MXD INFILL DEVELOPMENT CONCEPT PLAN

RESPONSE TO COMMENTS

CAMBRIDGE, MASSACHUSETTS
ISSUED NOVEMBER, 2016

IDCP RESPONSE TO COMMENTS

FIGURE R3.2.1

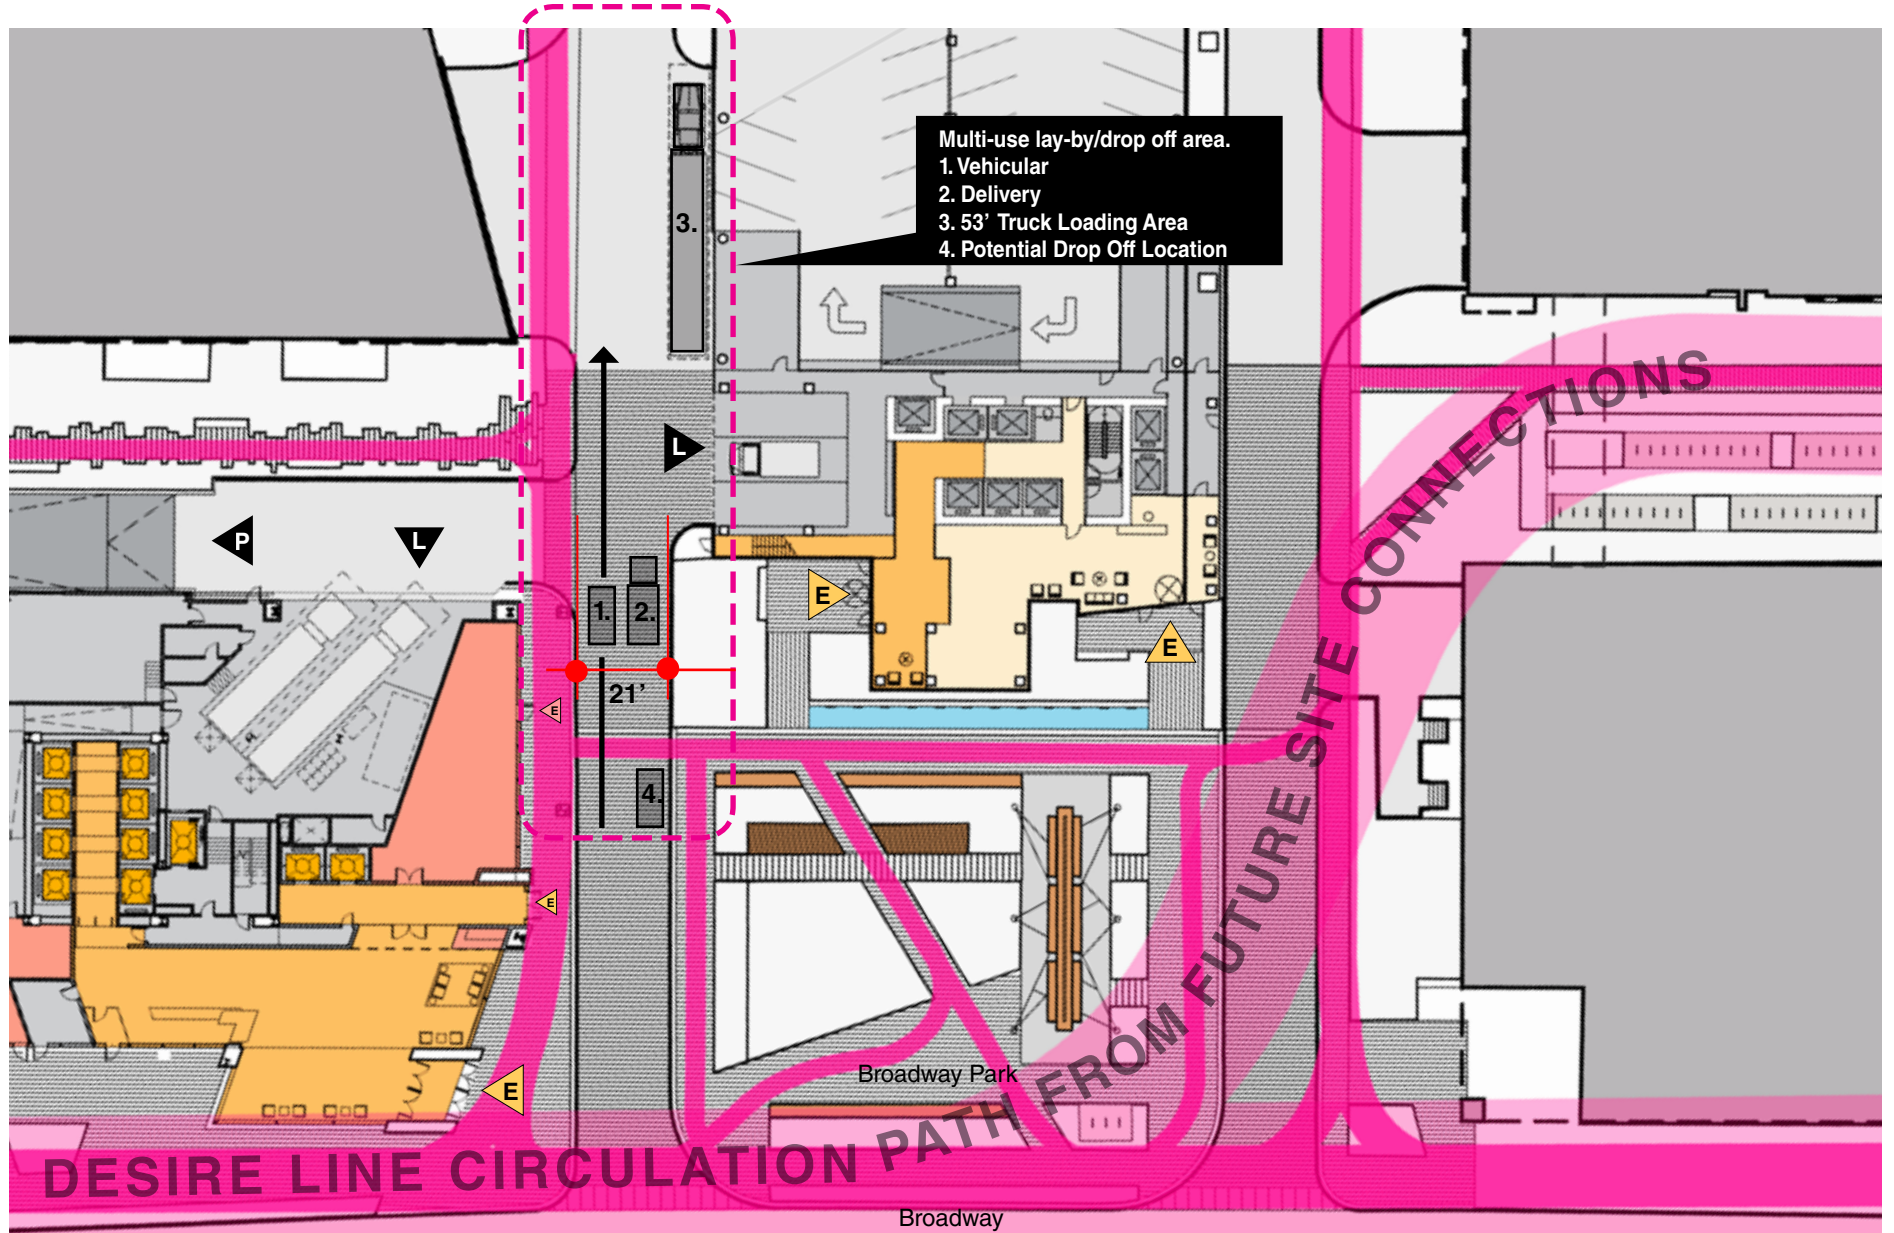
R3.2.1 DIAGONAL PATHWAYS: Applicant received different comments about the diagonal pathways and desire lines through the park. Applicant notes the comments and is willing to study desire lines further but recommends that this level of review occur at the time of design review for Phase II consistent with the MXD IDCP Chapter 9 Phasing Plan.

Applicant was asked to provide greater detail on visitor and delivery drop off for the residential and commercial projects. As shown on **FIG. R3.2.1**, a multi-use lay-by/drop off area is planned for the West Service drive in Phase II. This area is designed to accommodate a truck with a 53' lay by area as well as taxi and ride share drop offs, short term deliveries and pedestrian loading and unloading. In addition the service drives that exist today are designed to be wide enough to accommodate drop offs, breakdowns or deliveries while allowing for the continued circulation of traffic.

FIGURE R5.2.1

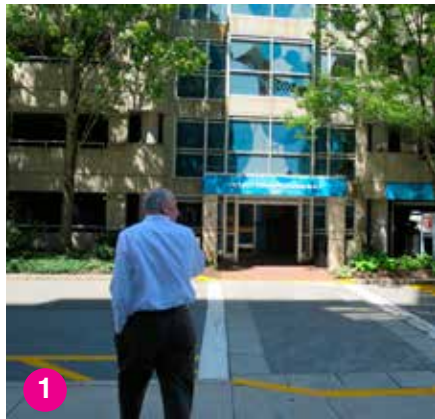
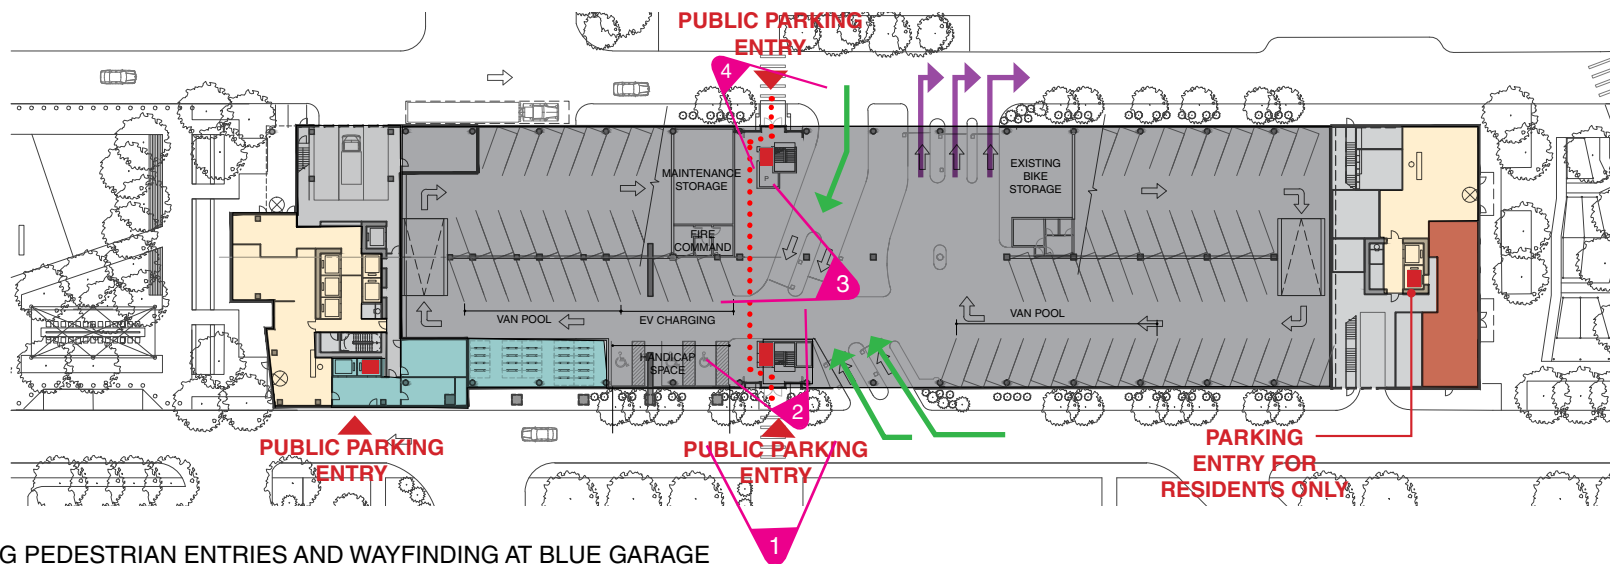
Applicant received questions on whether the Blue Garage as well as the garage at 145 Broadway and 250 Binney Street are planned to be publicly accessible **FIG. R5.2.1** and where visitor parking will be accommodated. The Blue Garage is publicly accessible and currently has 500 spaces allocated for commercial use. 145 Broadway and 250 Binney Street are not planned for public use but will be designed to accommodate visitor parking. The parking for the residential buildings is planned in the Blue Garage. Additional specific information on parking will be provided in the PTDM plan to be submitted by Applicant.

Applicant received comments requesting clarification on pedestrian access to the Blue Garage both during and after construction. The construction access plan will be developed in Phase II with other construction logistics plans in conjunction with other factors including vehicular traffic, bicycle circulation, construction staging and safety considerations that require further details that will be submitted through the Design Review Process. Pedestrian access for the Blue Garage in the final built condition is shown in **FIG. R5.2.1** with further refinement to occur when the Residential Projects submit a full Design Review package.

FIGURE R5.1

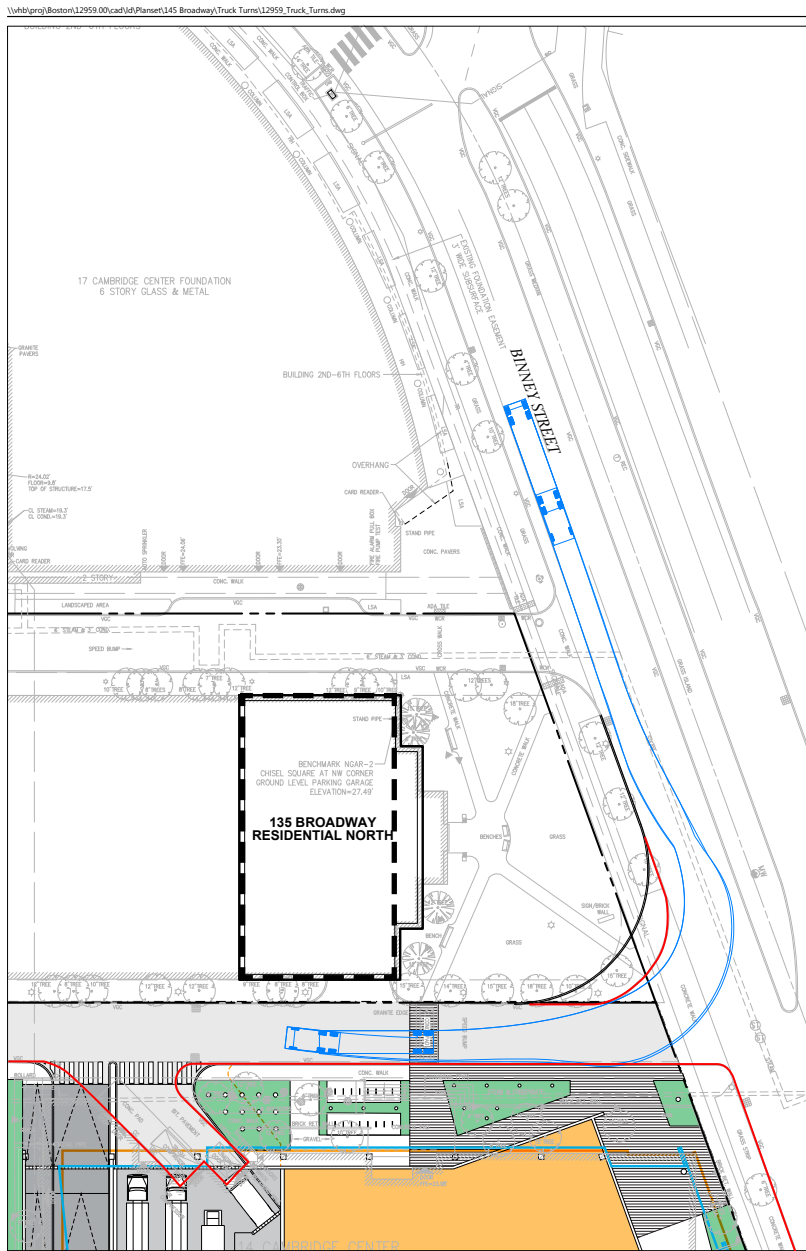
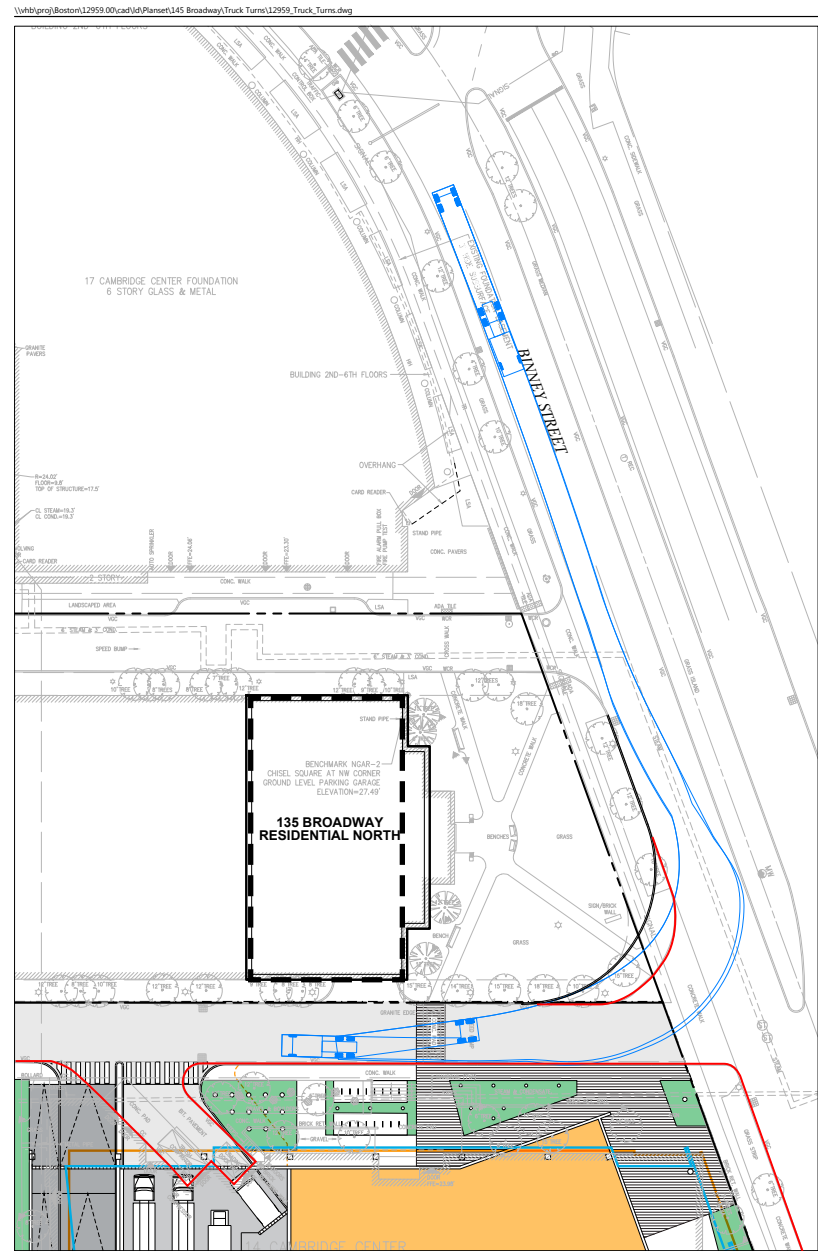
Applicant received the comment that the turning radius from Binney into the site was too large. The radius of that connection is designed to accommodate deliveries from trucks with 53' trailers as shown in **FIG. R5.5.1**

FIGURE R7.1.2

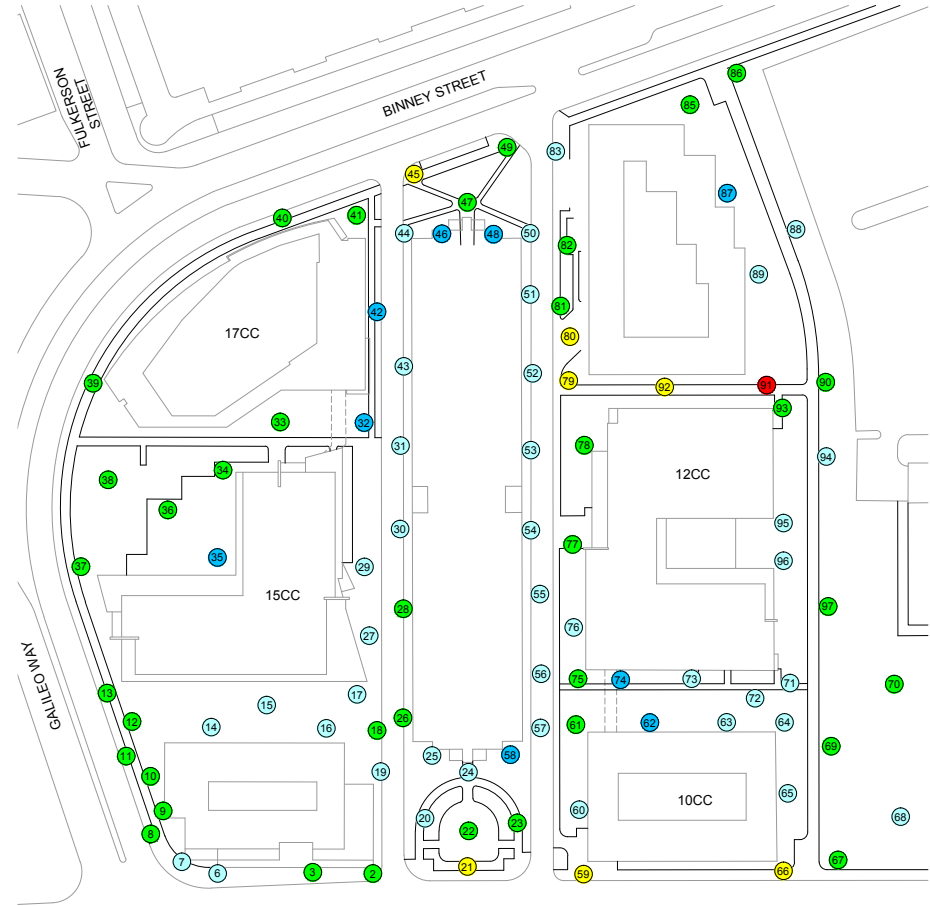
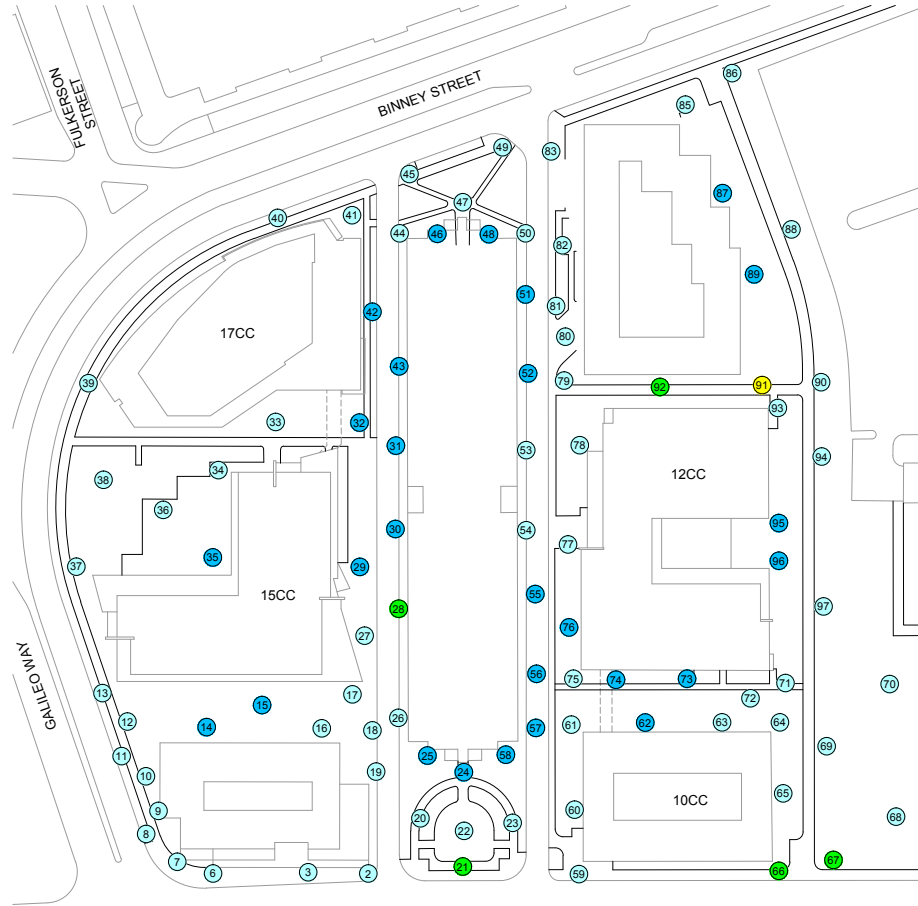
Applicant received general questions about wind and comments about the sufficiency of the desktop wind study provided in the MXD IDCP submission from August 9, 2016. Chapter 7 of the MXD IDCP included a selection of the desktop wind model run by RWDI on the initial massing of all four proposed buildings. In addition to these select elements of the analysis, the entire desktop study can be found in the appendices located on the CD rom attached in the back sleeve of the MXD IDCP book and submitted electronically to the Community Development Department. Applicant understands the concern about wind, however, wind tunnel analysis is sensitive to changes in massing. Accordingly, Applicant proposes that each building provide a wind tunnel analysis during Design Review after massing has been approved as part of the Infill Development Concept Plan and at a time when the building design can be appropriately altered to respond to a wind tunnel study. For the purposes of comparison, Applicant has included a wind tunnel analysis of existing summer and winter conditions **FIG. R7.1.2** serve as a baseline for future review.

FIGURE R9.1.1

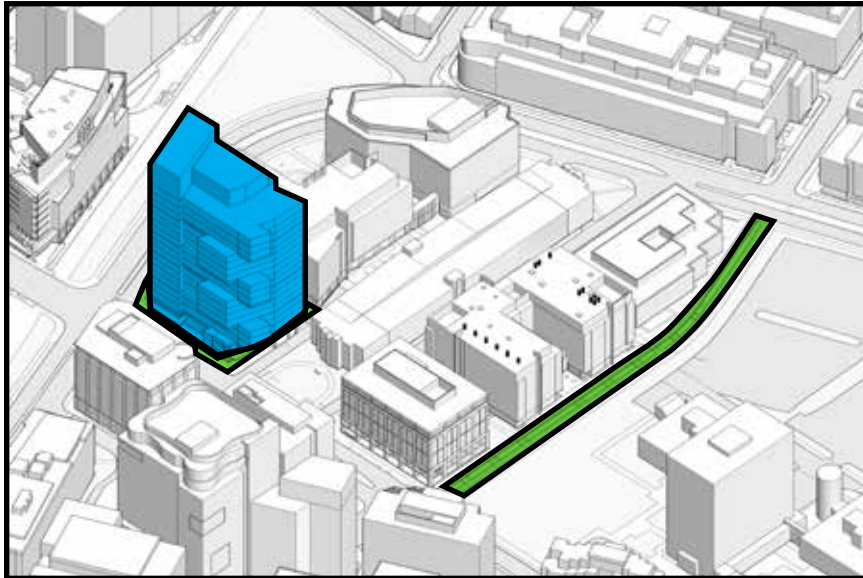
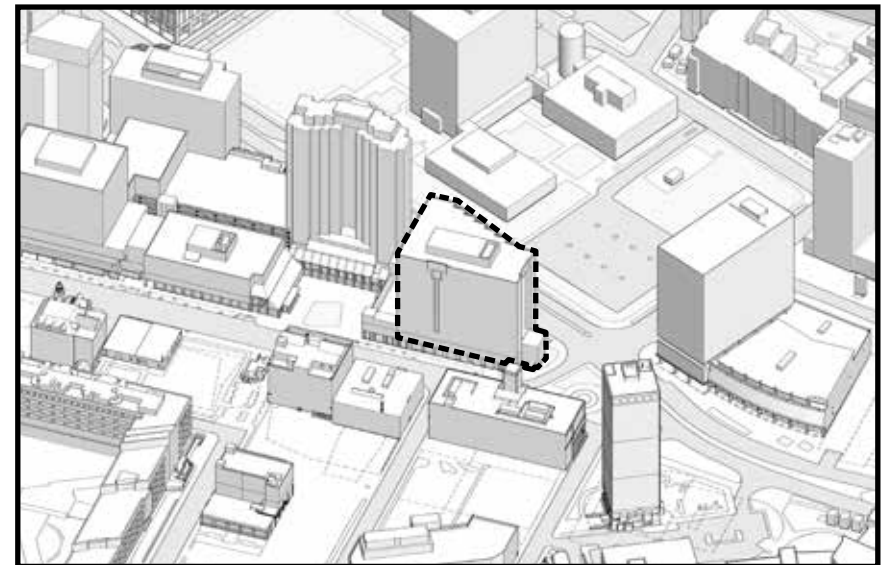
Applicant received multiple requests for clarification on the phasing of each open space related to the project including the parks and east to west pedestrian connector paths. A color-coded plan showing greater detail of the open spaces that will accompany each building and phase is represented in **FIG. R9.1.1** for Phase I, **FIG. R9.1.2** for Phase II and **FIG. R9.1.3** for Phase III. Also, describing the Open space related to project phasing is **IDCP revisions 3.2 Proposed Open Space**. Each phase indicates the required open space per allotted GFA for that phase and demonstrates that through provided open space and enhanced existing open space that each phase provides more than the necessary open space area.
